**The Woodlands Offsite Water Project
Solicitation Number: CO-00620
Job No.: 20-1248**

**ADDENDUM 3
January 6, 2023**

THE WOODLANDS OFF-SITE
WATER IMPROVEMENTS
WATER LINE P & P
STA. 57+00 TO STA. 68+50

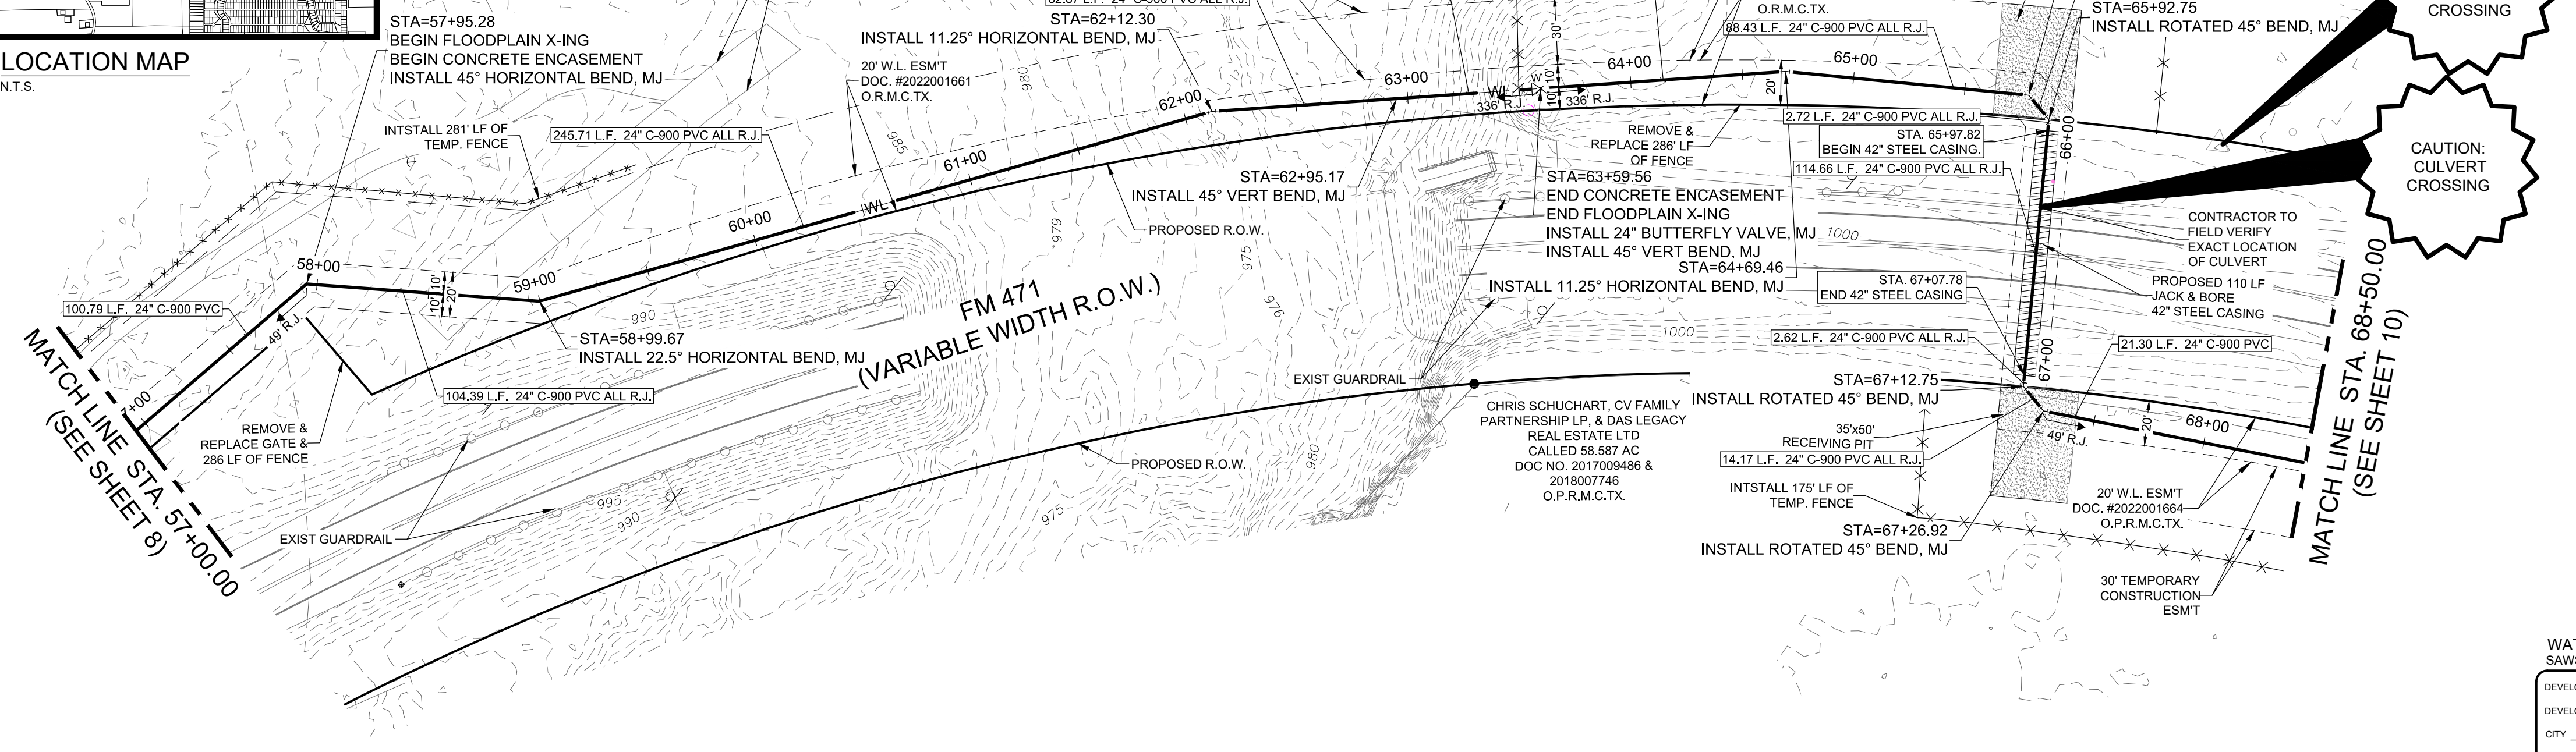
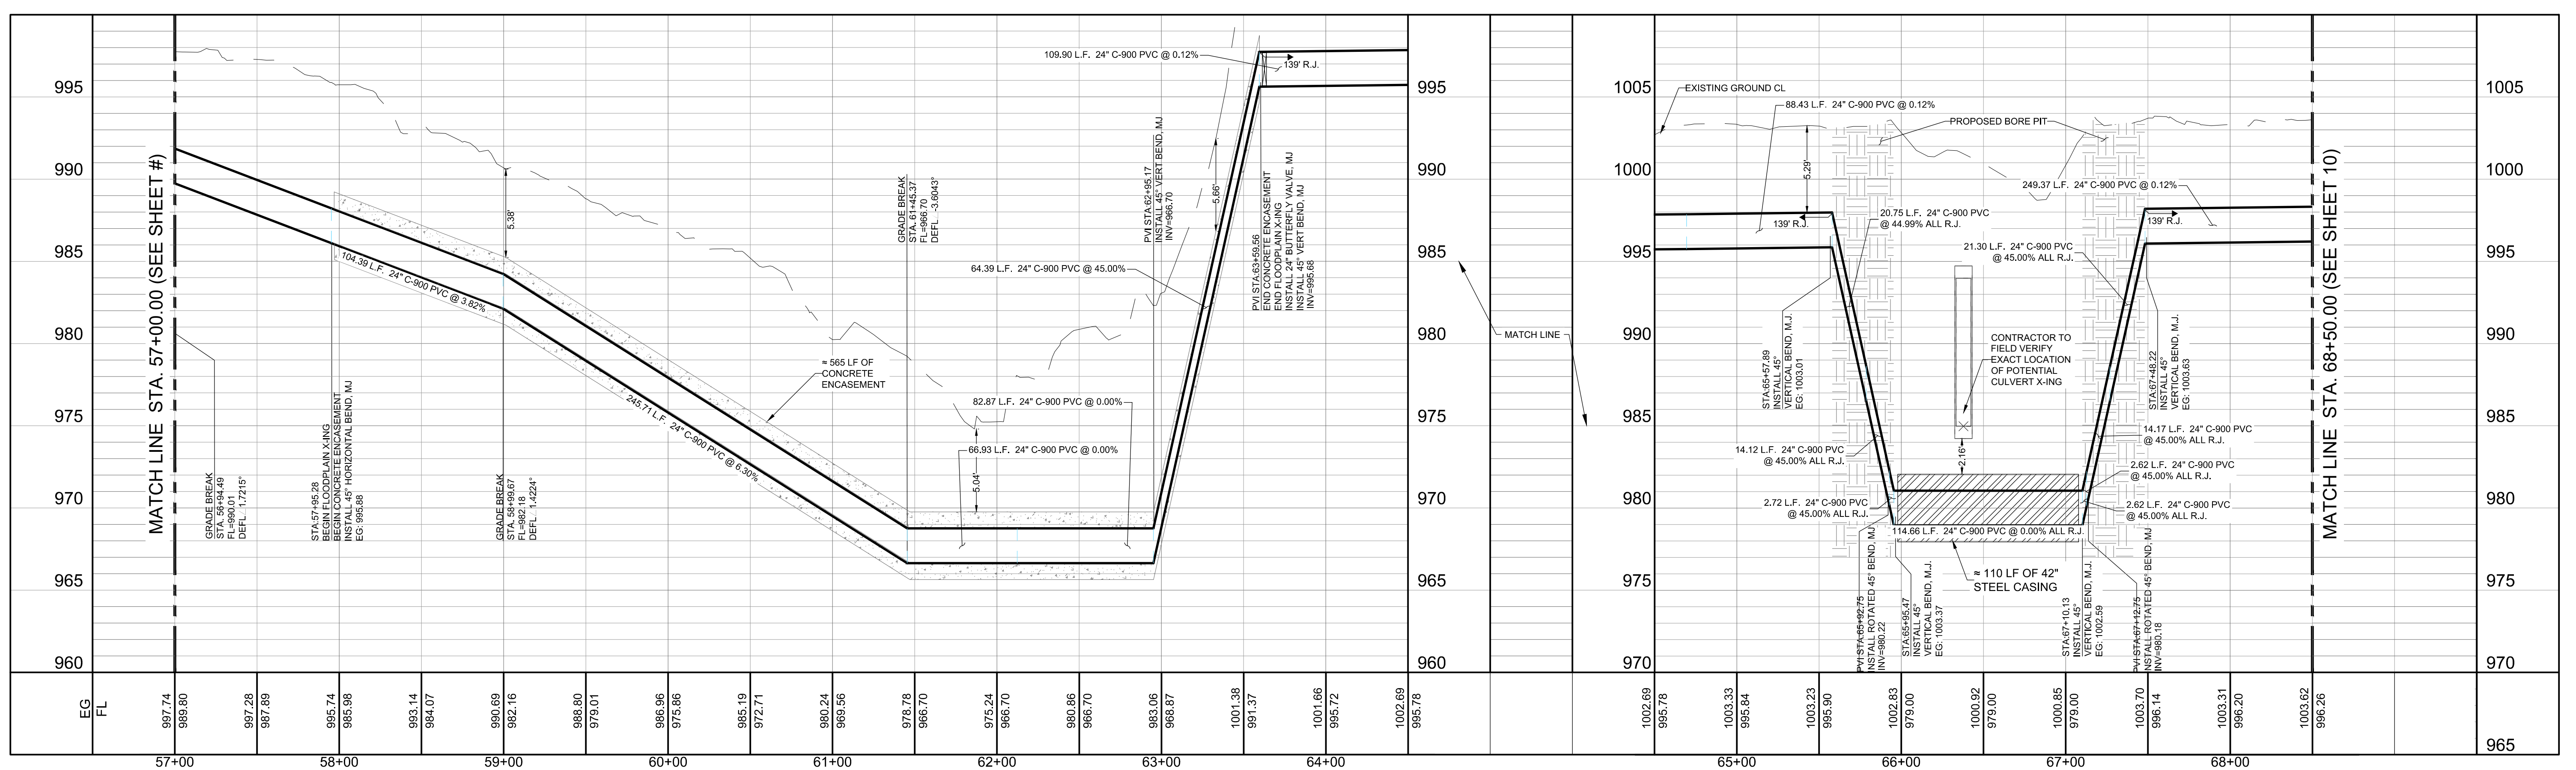
- 3. Question: There is a bore across FM 471 shown on sheet #9. The quantiles on the plans show 63.22' of jacking, boring, tunneling but the bore pits are shown at the edge of the right of ways with a separation distance of 120'. Is the bore going to be 63' or 120'?**

1. Remove and replace sheet 9 with the attached sheet 9. The length of the bore on sheet 9 has been revised.

Response: See #1, Changes to the Plans. The length of the jack and bore has been corrected.
